CONSULTING PARTIES PRESENTATION

THE WHITE HOUSE VISITOR SCREENING FACILITY PROJECT

CFA COMMENTS FROM 03/19/2026 CONCEPT SUBMISSION

PLAN VIEW: PROPOSED LANDSCAPE PLAN

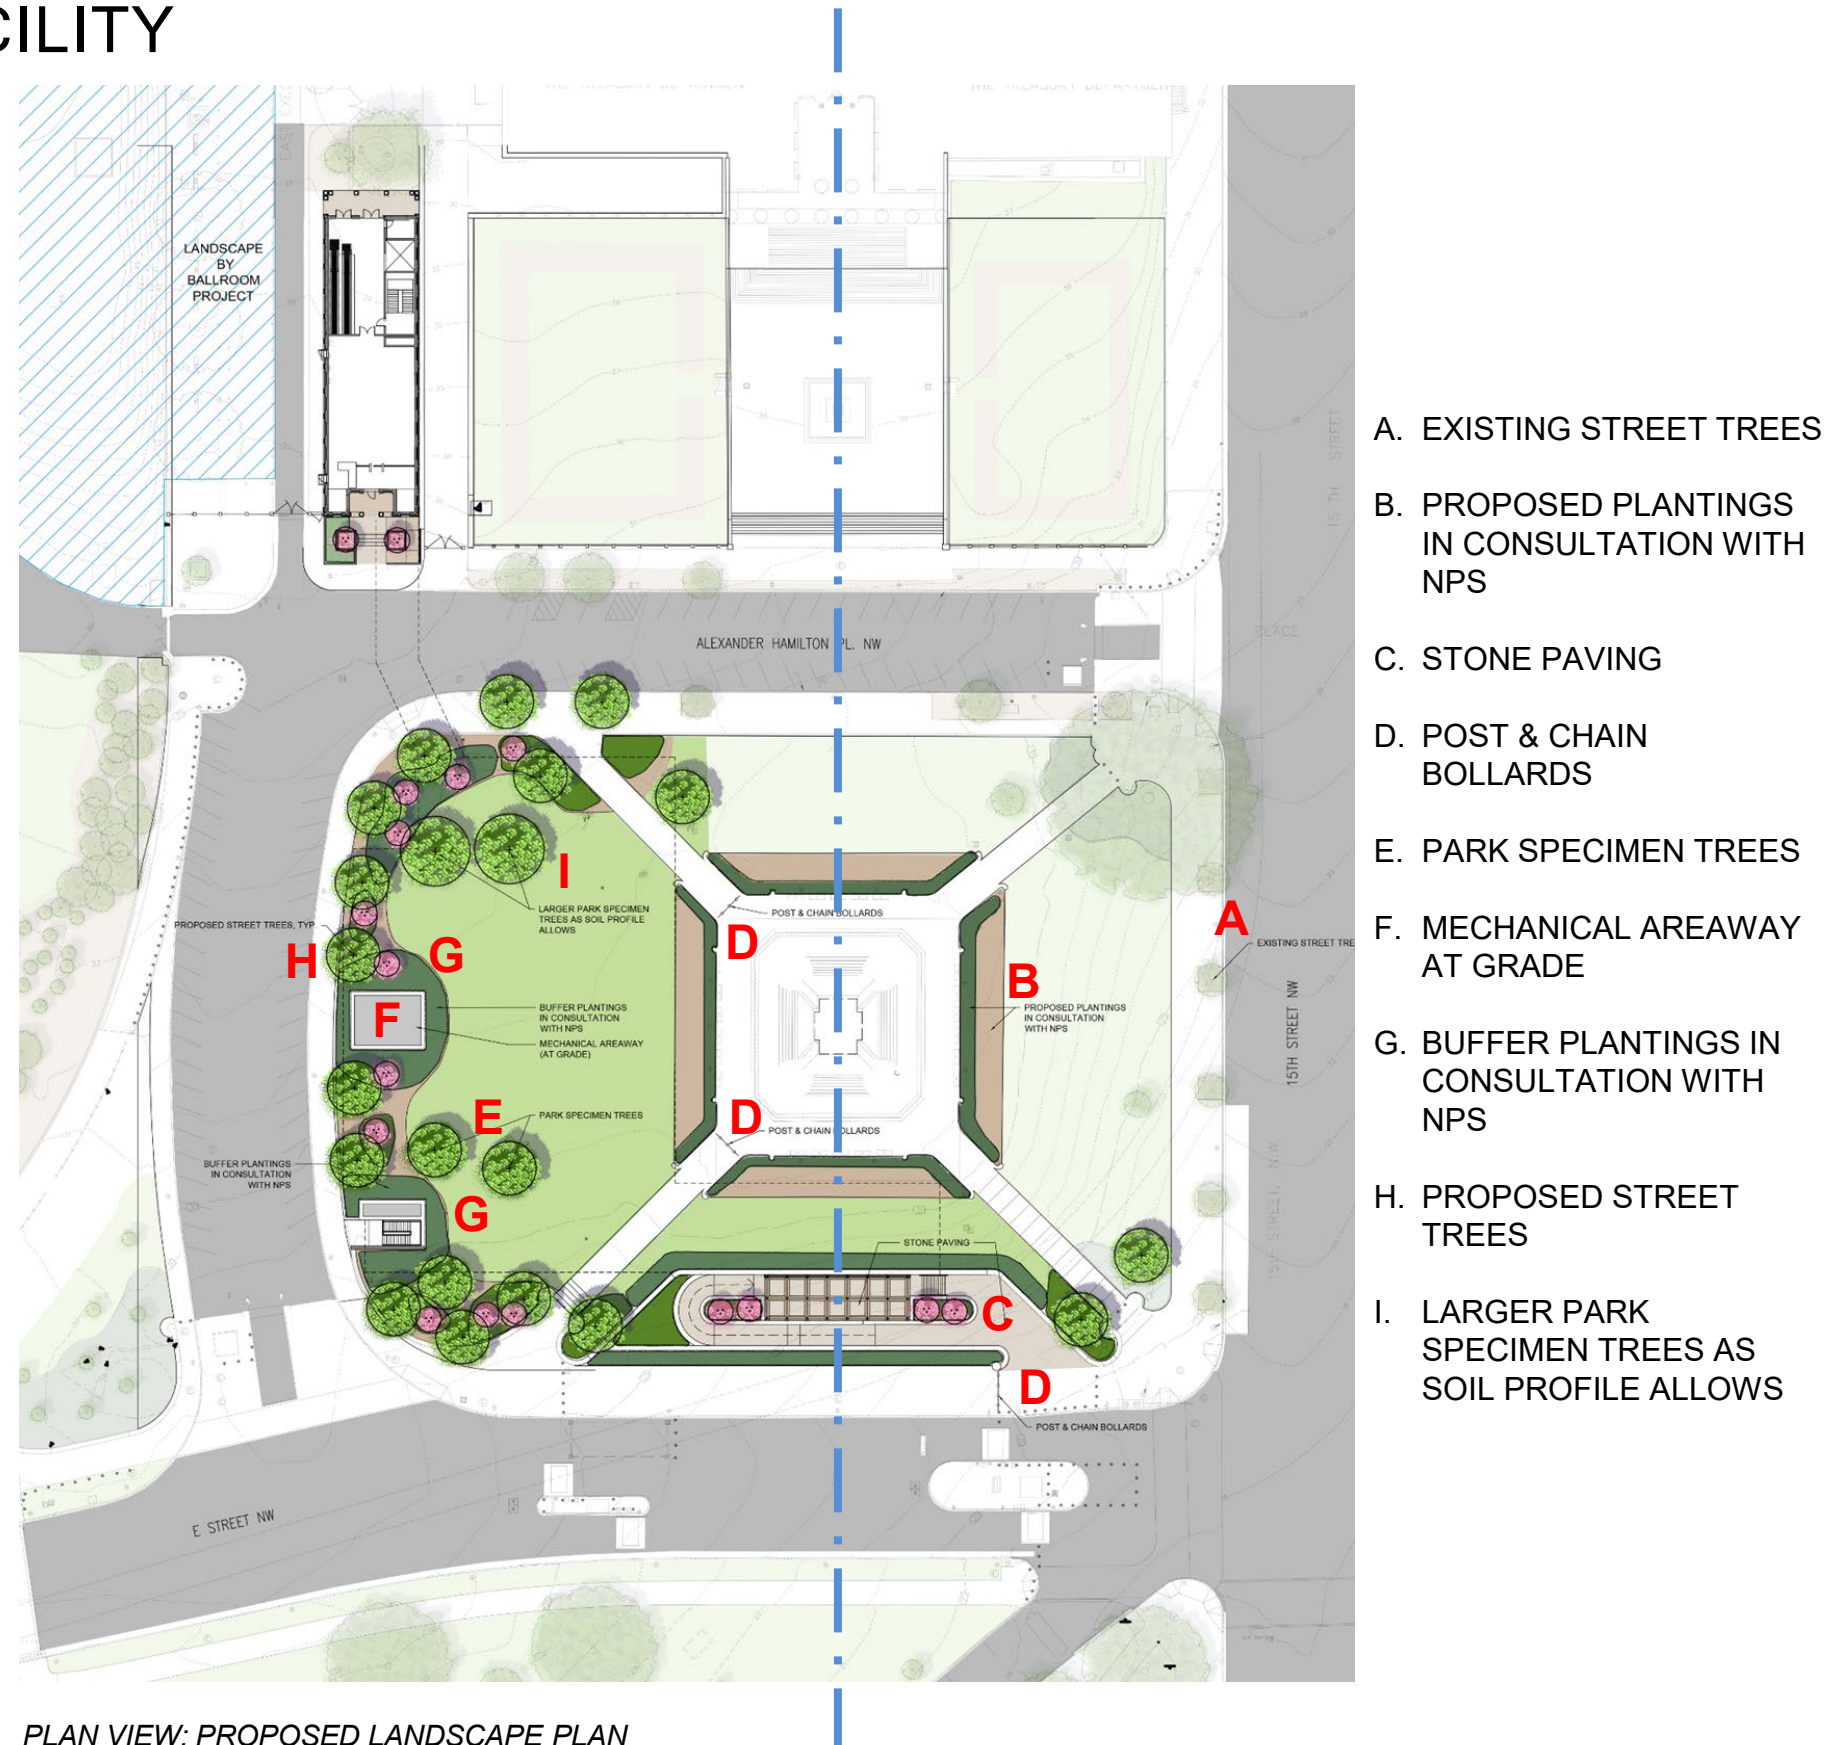
CFA Comment 3/19/2026 -

Provide a landscape plan:

CFA Comment 3/19/2026 -

Maintain historic landscaping and paving:

CFA Comment 3/19/2026 -

Review alignment with Treasury Building and Sherman Monument:

- The proposed landscape plan identifies all new trees, plantings, and grass areas planned within the scope of this project. Plantings around existing and new site walls will be selected and coordinated with NPS to provide a cohesive design that includes all 4 sides of the monument.
- The landscape design for the west side of East Executive Avenue across from the proposed exit building (location of existing temporary trailers) will be provided as part of the adjacent East Wing project.

- The existing historic pathways and retaining walls at each corner of the park will remain in the finished site condition, however, the northwest and southwest pathways will need to be removed and rebuilt to accommodate construction of the proposed facility below.
- Steps will be integrated into the rebuilt southwest pathway to clear the proposed structure below.
- The retaining walls framing the new plaza align with the existing curved corners on either side of the park's south quadrant. Where the side walls meet the primary south-facing entry wall, they maintain eased angles consistent with the historic site walls at the base of the monument.

- The proposed recessed plaza retaining walls and main entrance doors have been shifted east to align on axis with the Treasury Building and Sherman Monument.

RENDERING SHOWS VIEW OF FACILITY ENTRANCE RAMP AT E STREET AND 15TH STREET ADJACENT TO SHERMAN PARK

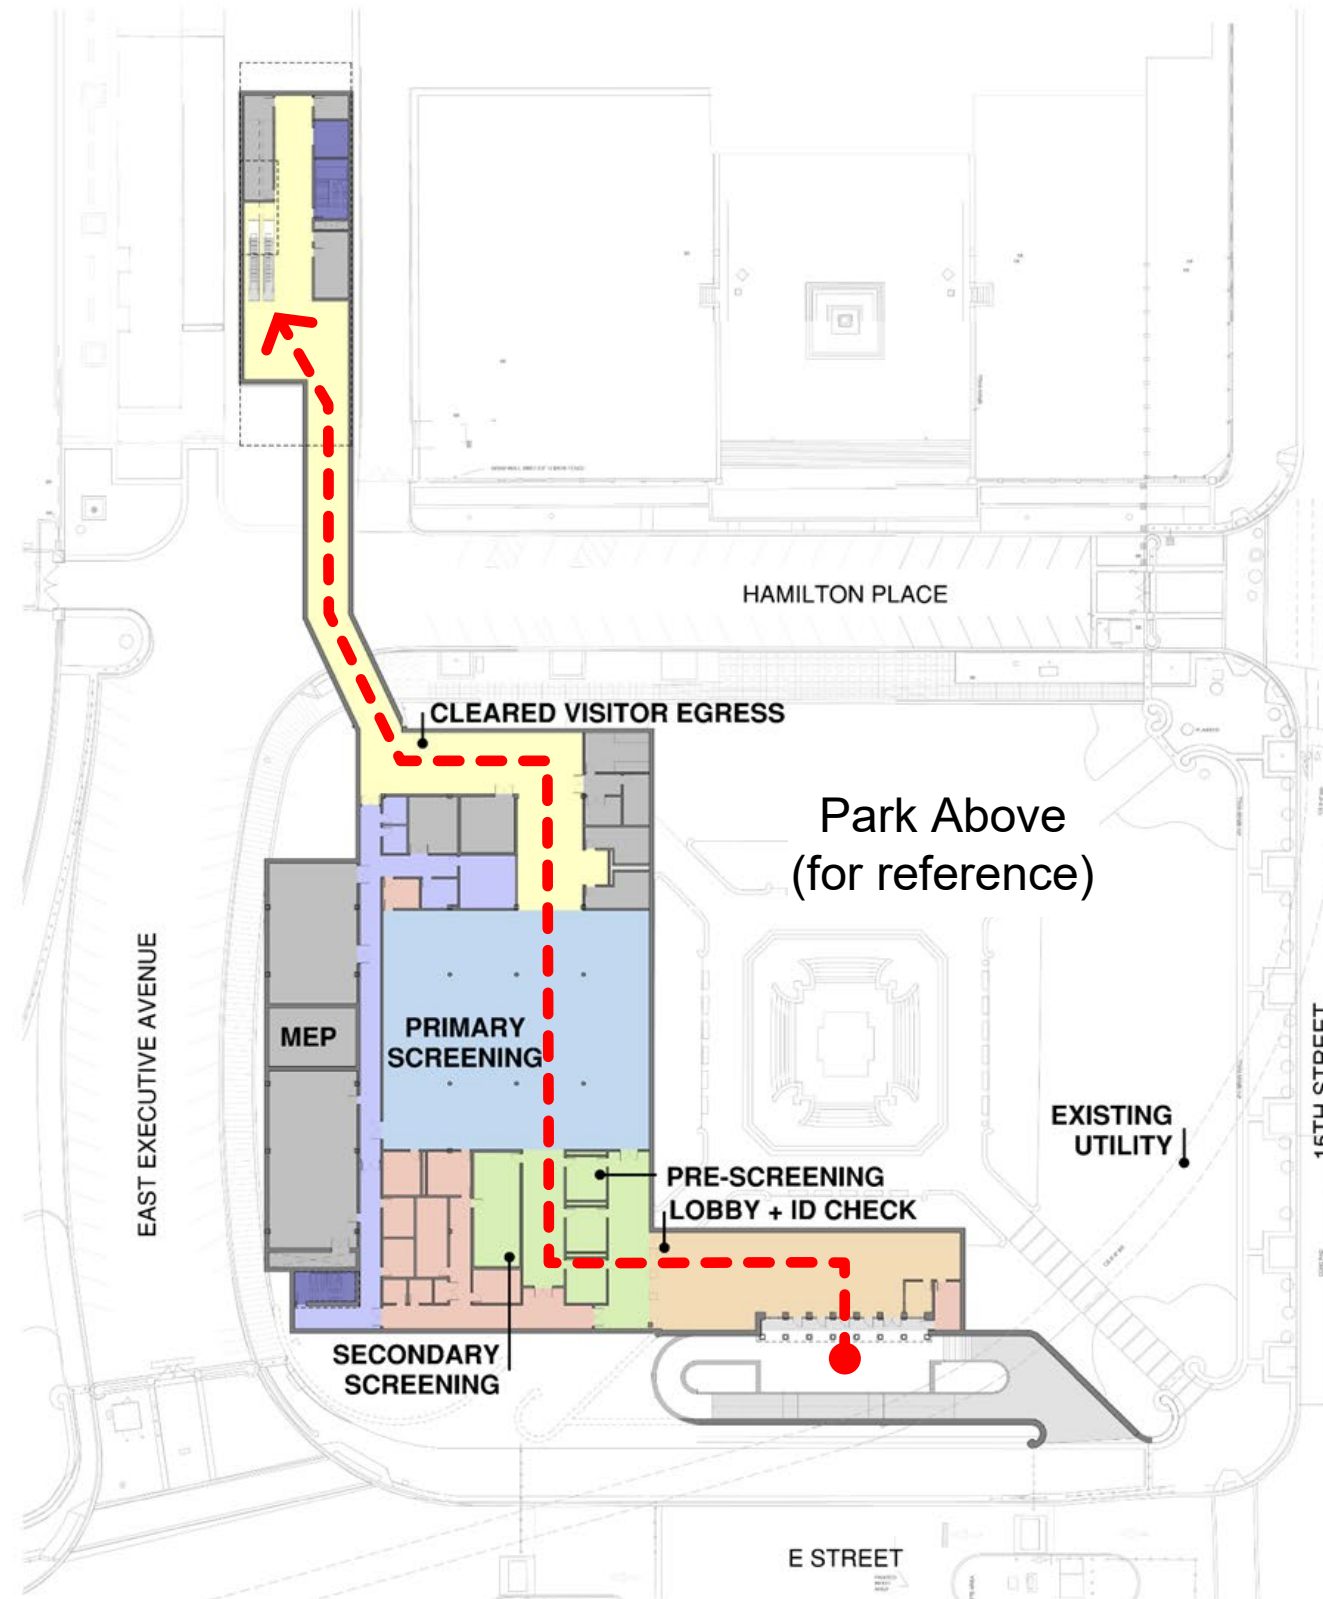
CFA Comment 3/19/2026 -
Review design to incorporate Executive Order on
Architecture

- Designed with a classical influence and aligned symmetrically on axis with the Sherman Monument and Treasury Building.
- 8 columns with entablature above - shown in Doric style to relate to the scale and prominence of surrounding buildings.
- Entry doors are set back with pilasters between doors to align with the colonnade.

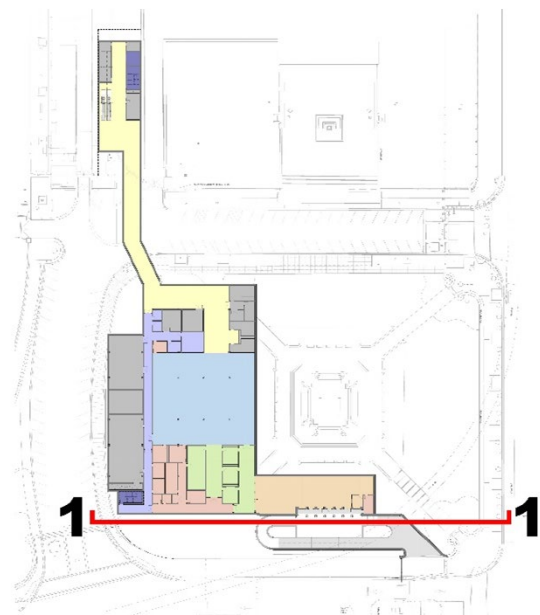
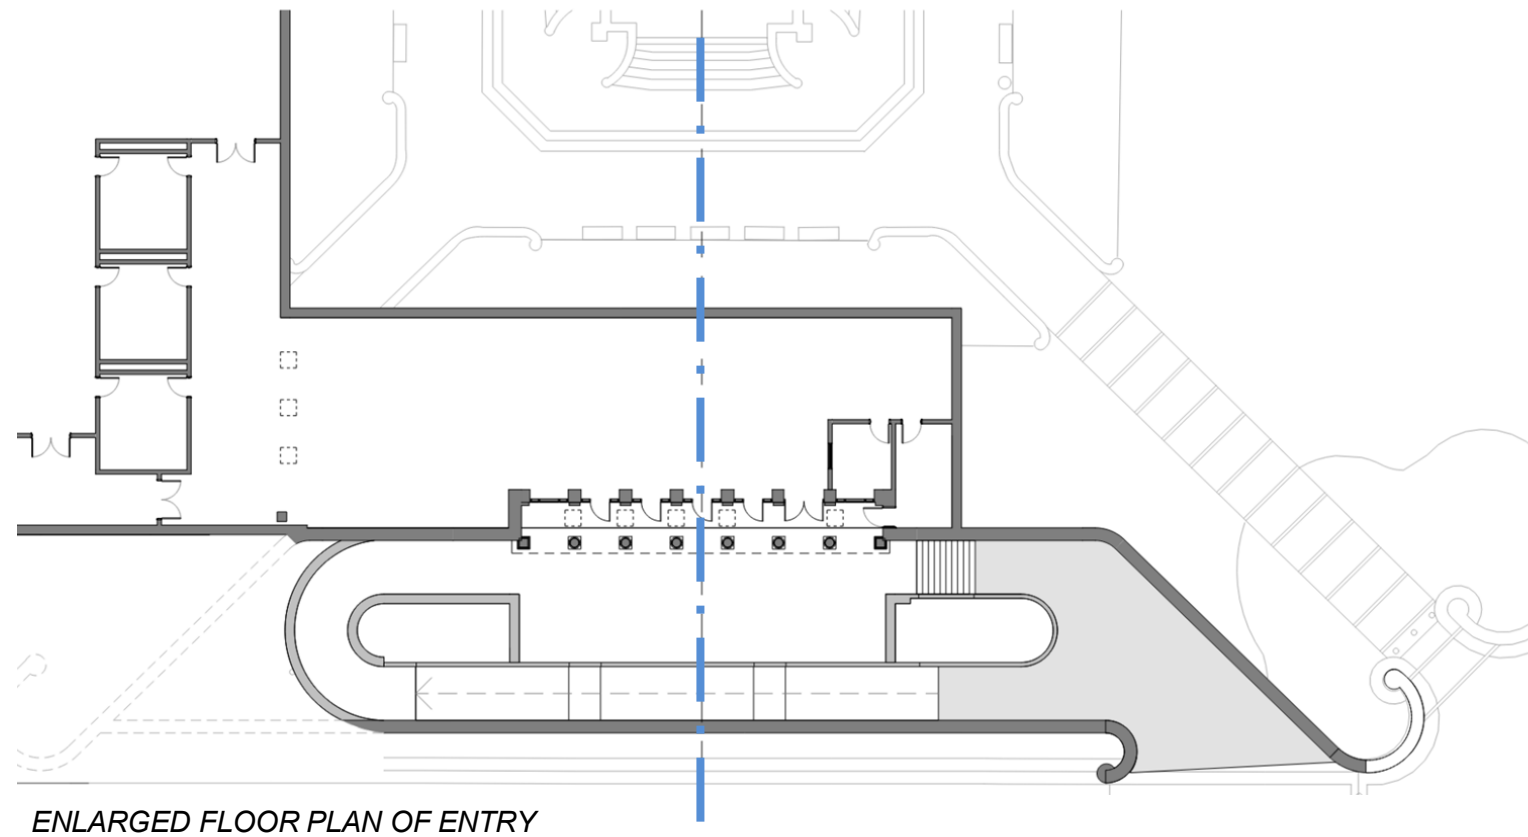
CFA Comment 3/19/2026 -

Review alignment with Treasury Building and Sherman Monument:

CFA Comment 3/19/2026 -

Review entrance design for potential artwork, etchings, or public art

- The proposed recessed plaza retaining walls and main entrance doors have been shifted east to align on axis with the Treasury Building and Sherman Monument.

- Proposing a refinement to the retaining walls that visually reduces their scale through the introduction of banding and granite texture, reinforcing human scale while preserving material purity.

SECTION SHOWING ENTRANCE TO FACILITY BELOW SHERMAN PARK

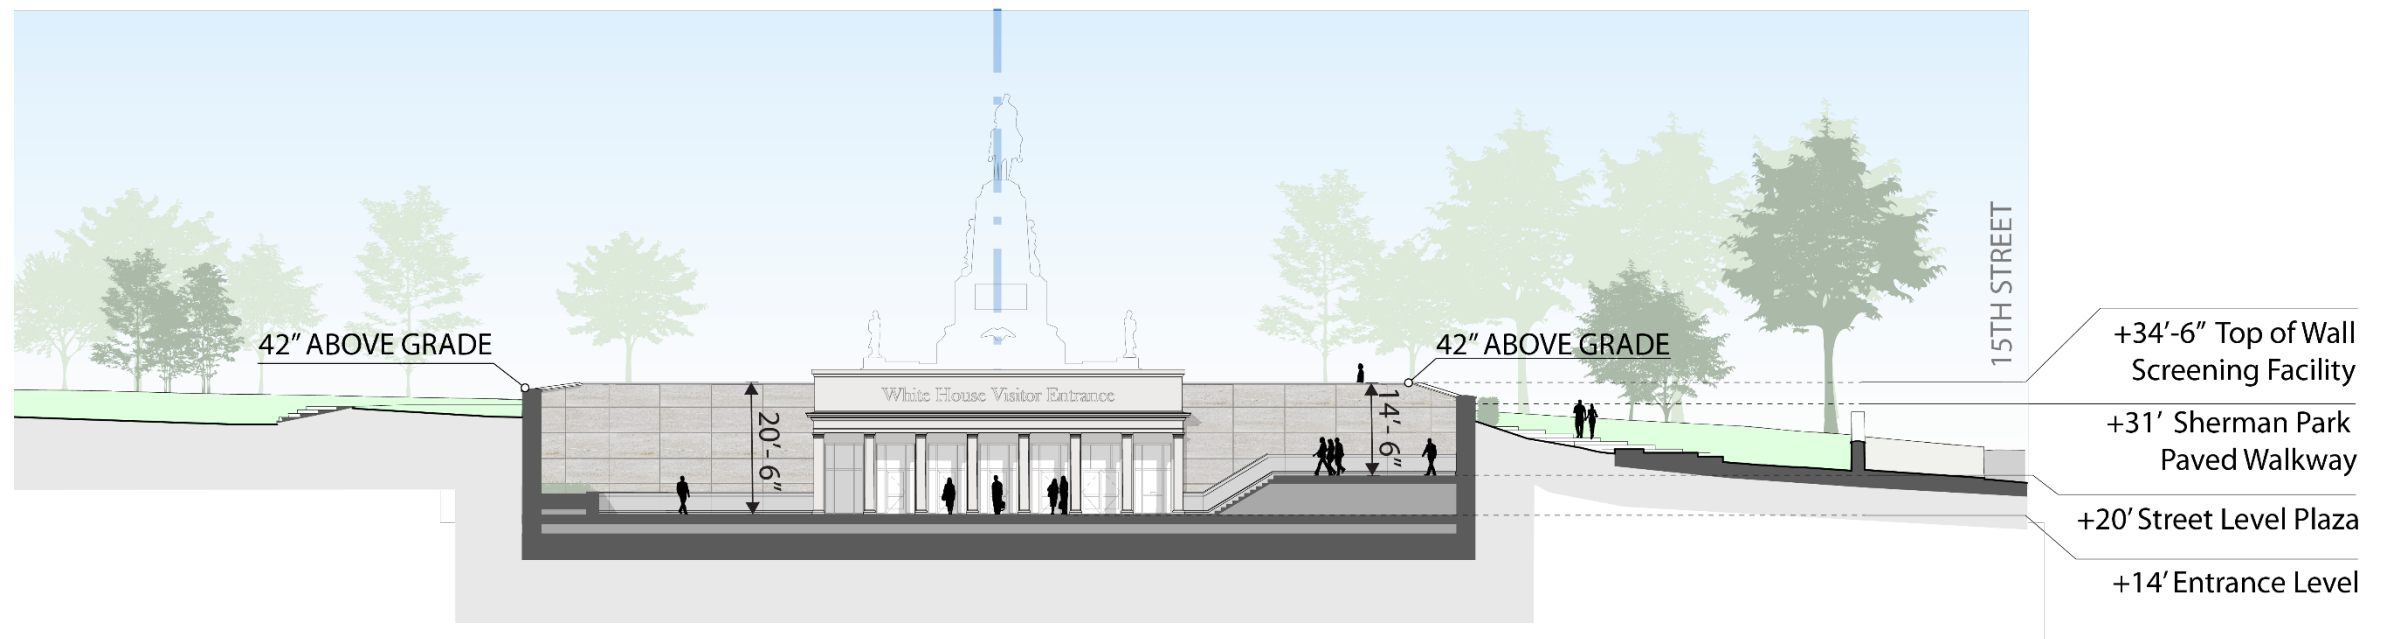
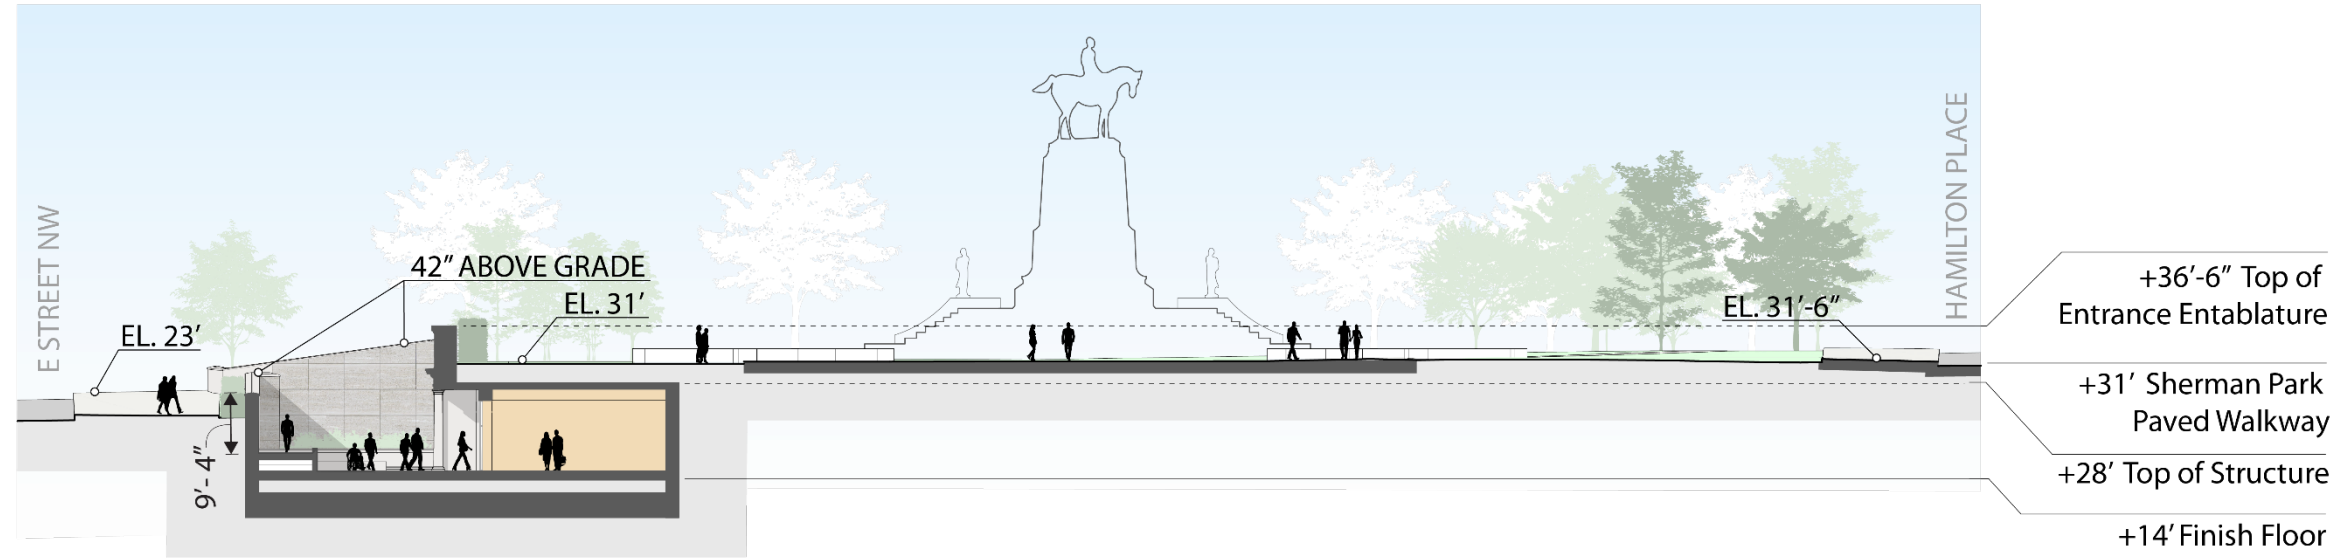
CFA Comment 3/19/2026 -
Reduce retaining wall heights :

- Retaining walls match existing heights where possible or set at 42" above finished grade with landscaping adjacent.
- To reduce the prominence of walls within the plaza - ramps and stair walls will remain low with ornate guardrails and handrails where required.
